Subject: AR0020702_Bad Boy facilities 1 and 2 ARP001027 ARP001028 updated schematics

Thank you for the updated schematics and tank volumes for your 2 facilities. These will replace the ones sent in with your two initial baseline monitoring reports.

Bad Boy #2

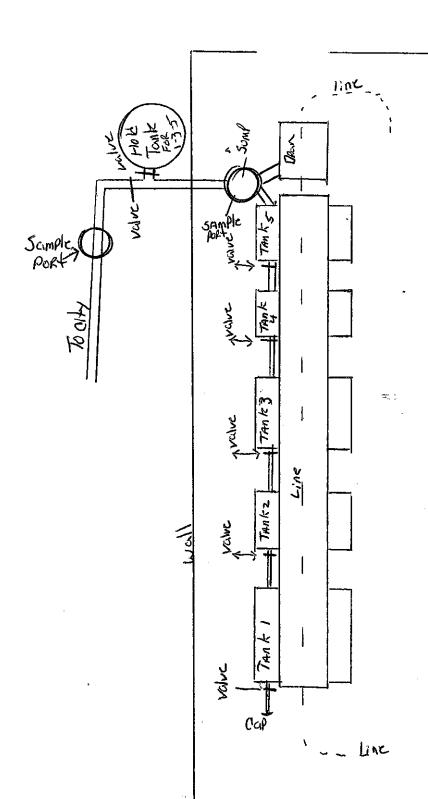
Both schematics show two separate sampling points. It is stated in your two baseline monitoring reports sampling for compliance of the rinse waters will be taken from the sumps inside the plants. If that is not correct, please advise. It is important to know the correct sampling point for compliance with the Federal Metal Finishing limitations in 40 CFR 433.17.

Stages 1 3 & 5 is cut off from the city when dumping and captured in holding tank. No process water from stage 2 & 4 is on at that time on both Bad Boy 1 & Bad Boy 2.

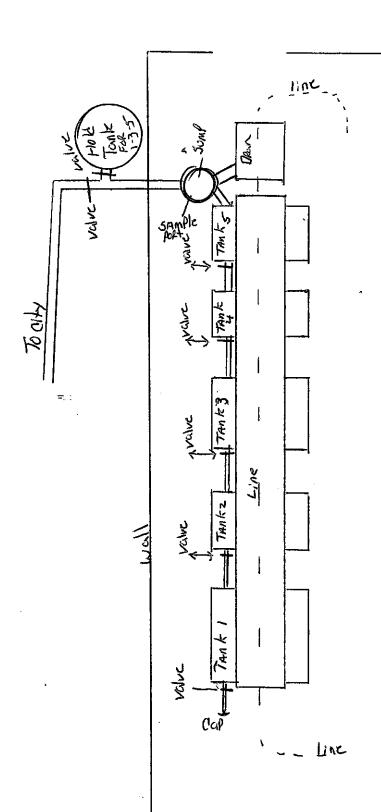
The footnotes included on your schematics helps explain to any interested party that your "work tanks" 1, 3 and 5 are hauled off-site for disposal separately from the rinse tanks 2 and 4 which are discharged to the City.

* 1-3-5 Is cut off From the city when Dumping and captured In Holding tank. NO Process water Is on at that Time.
